## Responses to Council Questions and Comments

12/16/2024

### **Item #10: Certify a Final Environmental Impact Report (Final EIR), Adopt Findings of Fact and a Statement of Overriding Considerations, and Adopt the Mitigation Monitoring and Reporting Program (MMRP) for the Creekwood Housing Development Project at 270 and 280 Casa Grande Road; APN(s): 017-040-051 and 017-040-016. City Record No. PLSR-2021-003**

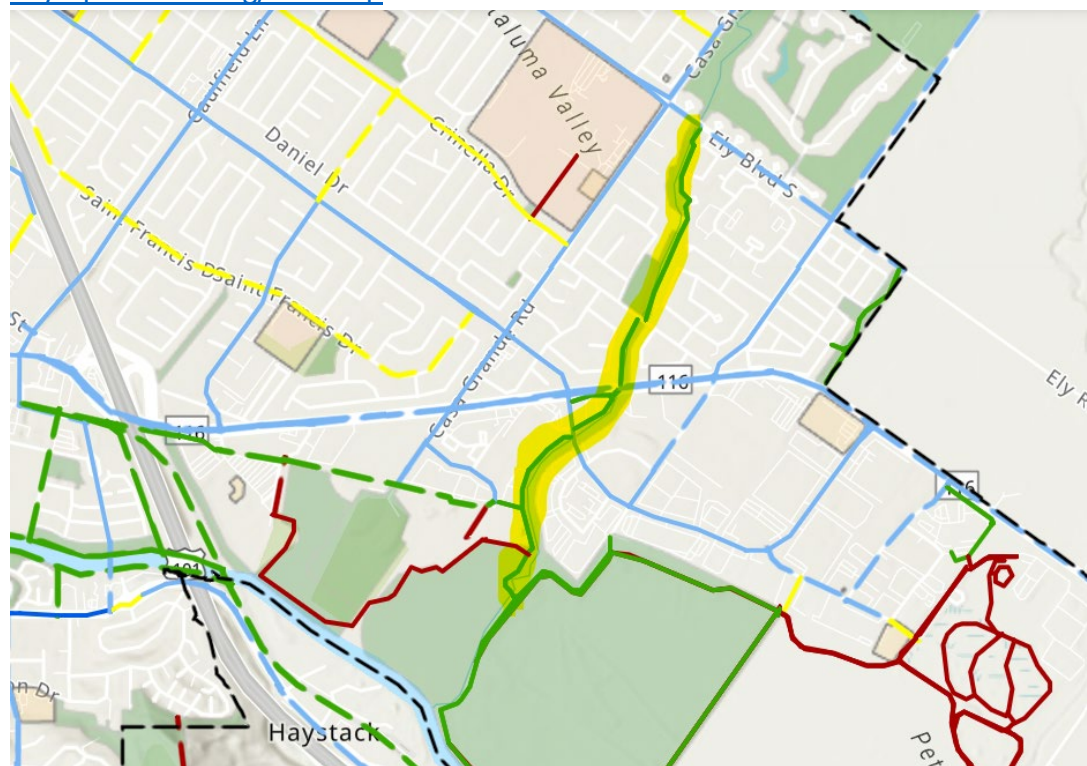
- **Question:** Could the current path/trail on both sides receive some upgrades?
  - **Response:** Adobe Creek Trail is not currently in our CIP for robust improvements, such as paving, but there may be opportunities to make minor improvements using our PW crews.

The primary feedback we hear about Adobe Creek Trail is the desire for an undercrossing (probably not feasible) or signalized crossing (subject to Caltrans approval) at Lakeville Highway. Adobe Creek Trail has immense potential but is limited by the lack of a crossing at Lakeville Highway. It would feed directly into Shollenberger Park and will be an amazing connection for the southeast neighborhoods, especially once the PIPS and River Trail projects are complete.

Screenshot from draft bikeway network under development for Active Transportation Plan (Adobe Creek Trail highlighted) below. Full PDF available here: <https://cityofpetaluma.primegov.com/Portal/viewer?id=0&type=7&uid=f77c177e-d0f8-4b3b-868b-f4ffe1a93e6c>

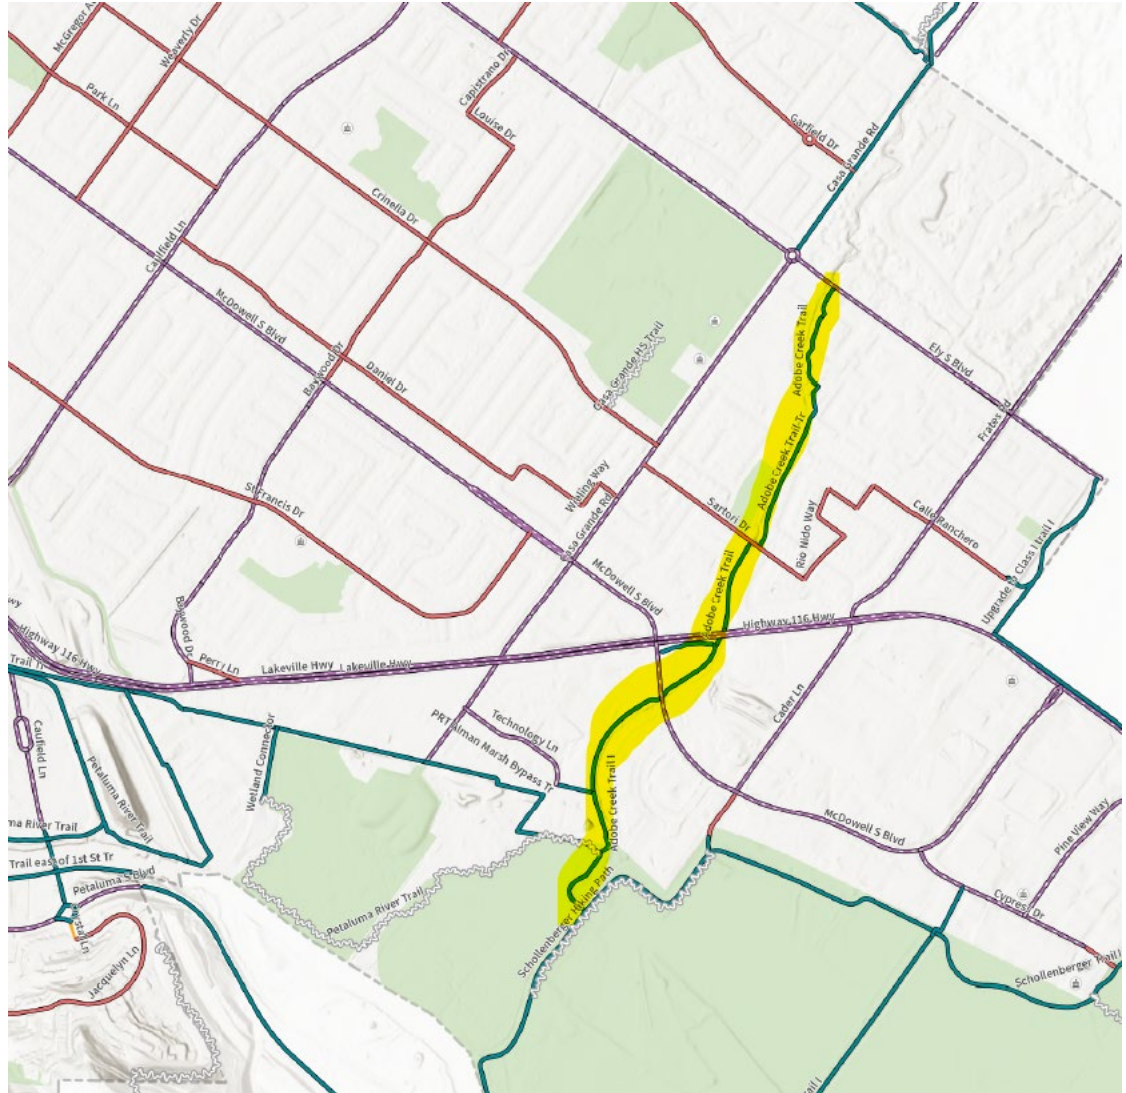
- **Question:** Can the map of the (ATP) Active Transportation Plan showing the connection from the proposed bridge and how it connects to Lakeville, then the proposed bike and pedestrian trail to Ellis Creek be provided?
  - **Response:** Screenshot from 2008 Bicycle & Pedestrian Master Plan (Adobe Creek Trail highlighted) below. Interactive map with legend available at [cityofpetaluma.org/bikemap](http://cityofpetaluma.org/bikemap)
